CITY of NOVI CITY COUNCIL

Agenda Item 2
December 8, 2014

SUBJECT: Consideration of the request of Toll Brothers for JSP 14-18 with Zoning Map Amendment 18.707 to rezone property in Section 26, on the east side of Novi Road, south of Ten Mile Road from I-1, Light Industrial and OS-1, Office Service to RM-1, Low Density Low-Rise Multiple-Family Residential with a Planned Rezoning Overlay. The property totals 20.9 acres and the applicant is proposing a 93 unit attached condominium multiple-family residential development.

PLAN REVIEW CENTER REPORT

SHEET 2

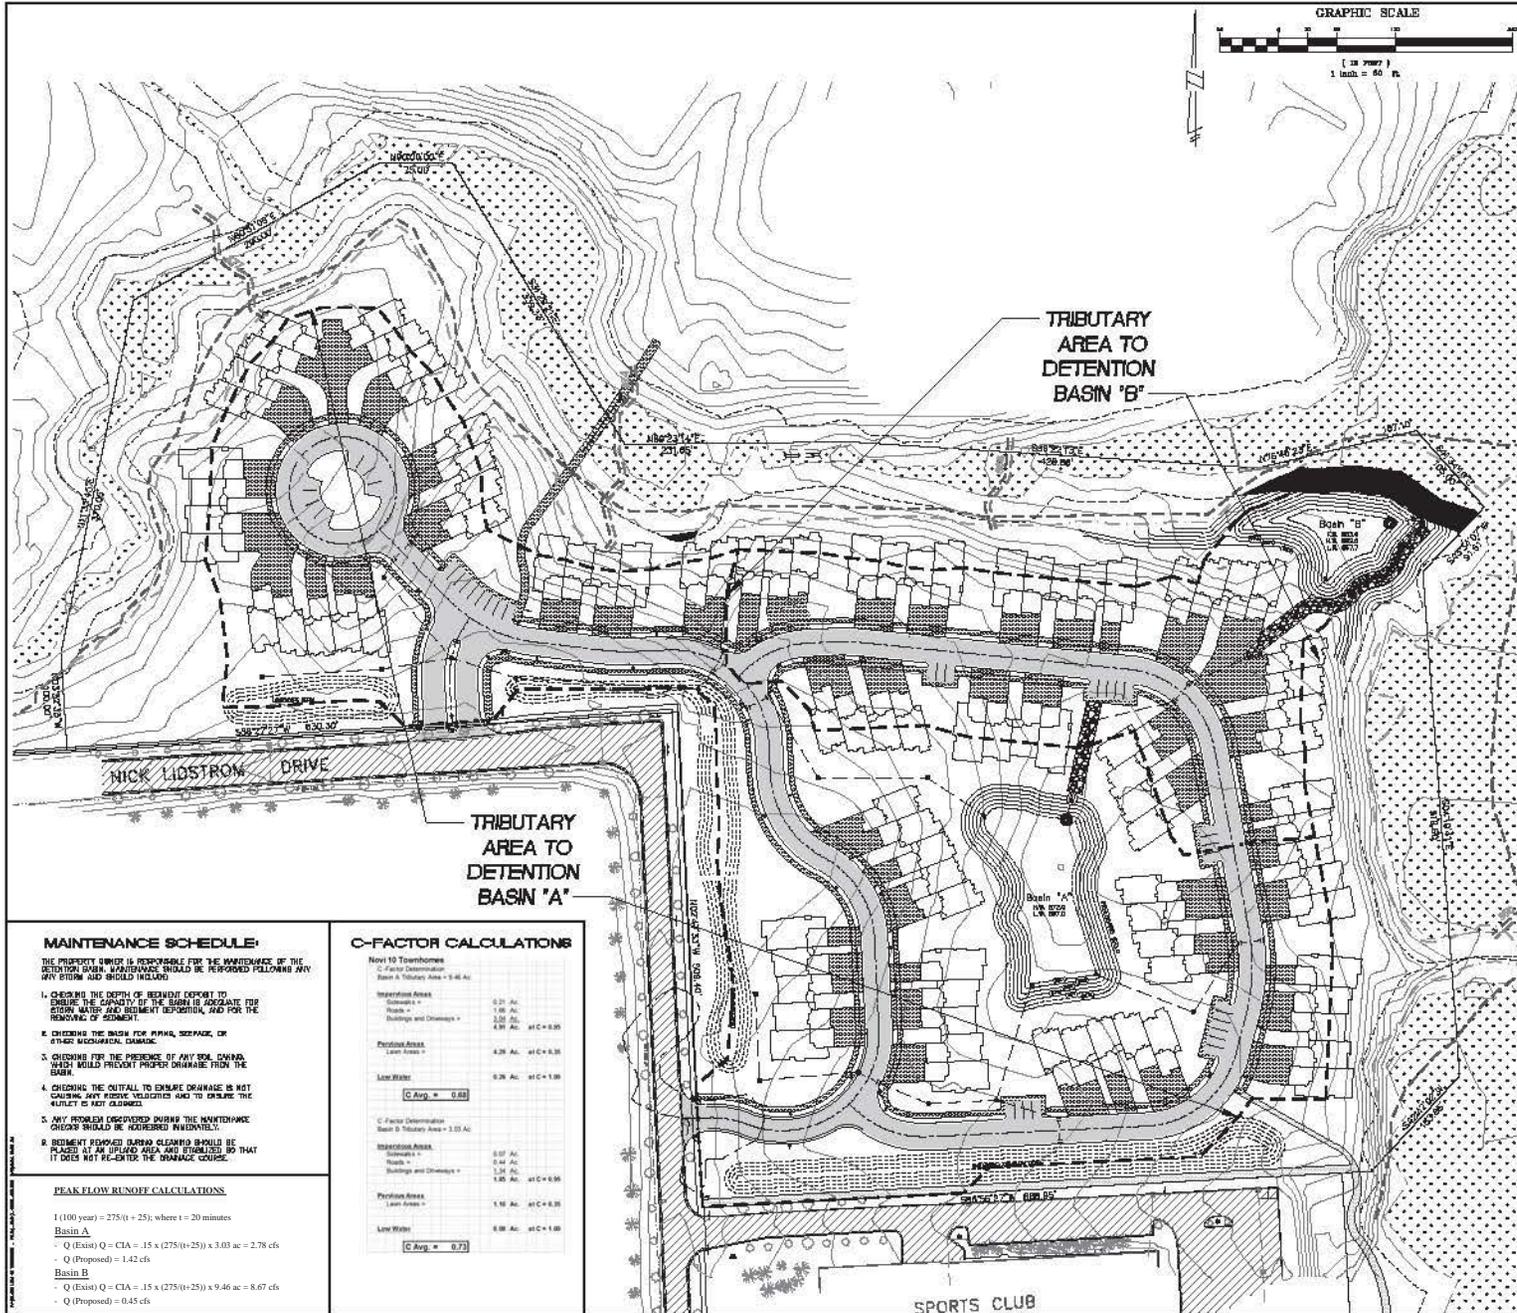
The *Planned Rezoning Overlay Plan* (Sheet 2) indicates areas of wetland surrounding the proposed development site. As noted, these wetland areas were delineated by King & MacGregor Environmental, Inc.

Currently, the Plan does not indicate proposed, direct impact to wetlands. However the Planned Rezoning Overlay (PRO) Plan (Sheet 2) does indicate a proposed 8’ wide pedestrian boardwalk/bridge. The impacts associated with this work do not appear to be indicated or quantified on the Plan. Subsequent site plans should include a detailed description of both permanent and temporary wetland and wetland buffer impacts associated with this proposed boardwalk/bridge.

While the Plan includes proposed impacts to on-site wetland buffer, the Applicant has made an attempt to minimize proposed wetland disturbance. The following table summarizes the existing wetlands and the proposed wetland impacts as listed on the *Planned Rezoning Overlay Plan* (Sheet 2):

Woodland Summary

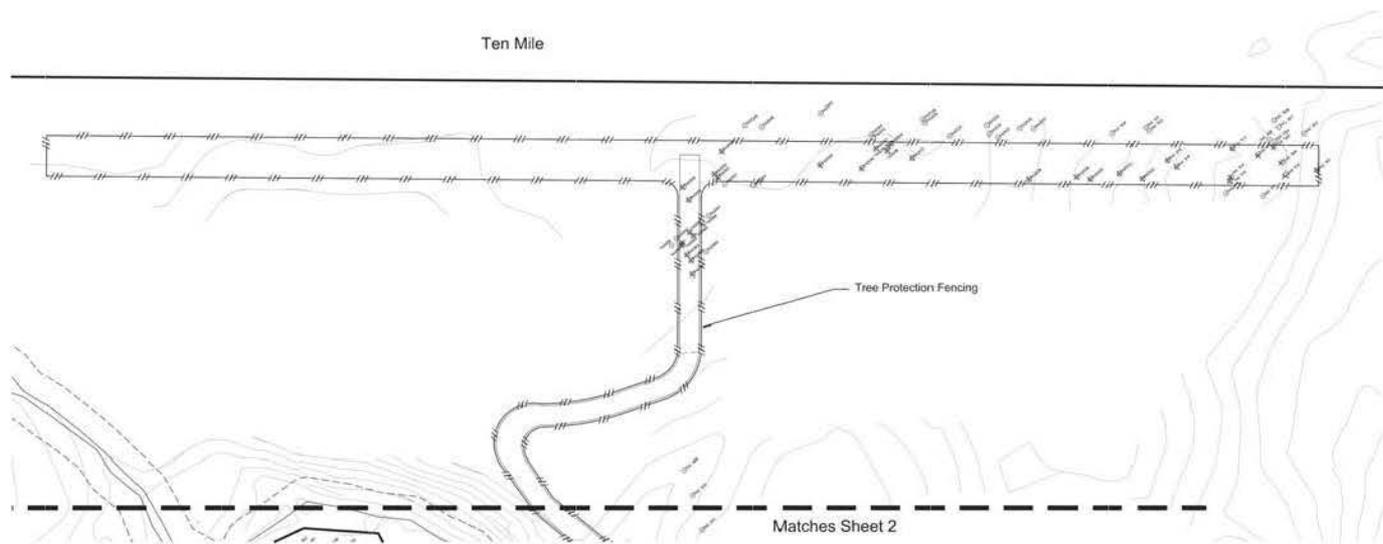
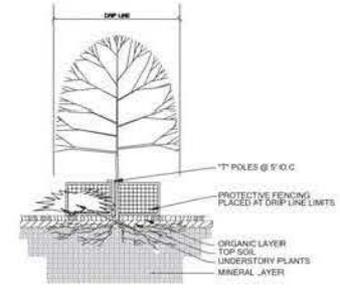
A *Woodland Plan* (Sheets L-2 & L-3) and *Woodland Tree List* (Sheet L-4) have been provided with the Plan. The existing site woodland information (tree sizes, species and conditions) have now been provided by the Applicant. In addition, proposed impacts to on-site regulated woodlands have now been described/quantified.

A *Woodland Summary* Table has been included on the *Woodland Plan* (Sheet L-3). The Applicant has noted the following:
